Access Compliance Report

Public Rights-of-Way

(Pedestrian Signals)

Intersection ID: N/A	Main Street:	Cross Street: N/A	Location: N/A
ADA ID: 25EBCA767EDF	Signal Type: One Push Button-APS	Overall Compliance: No	Severity Score: BTN 1: N/A BTN 2: N/A No BTN: N/A
Codes/Mitigation Info/Possible Solution		Field Measurements/Component Compliance

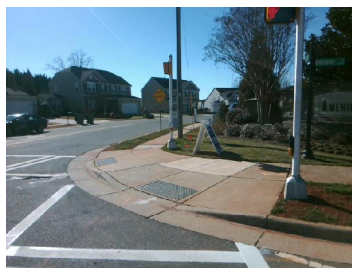
PROW/ADA: R404.2, R404.3, R406.2, R209.1,
MUTCD 4e.10

Possible Solutions: Remove & Replace
Replace APS Button With New APS Button.
Remove and Replace Clear Space.
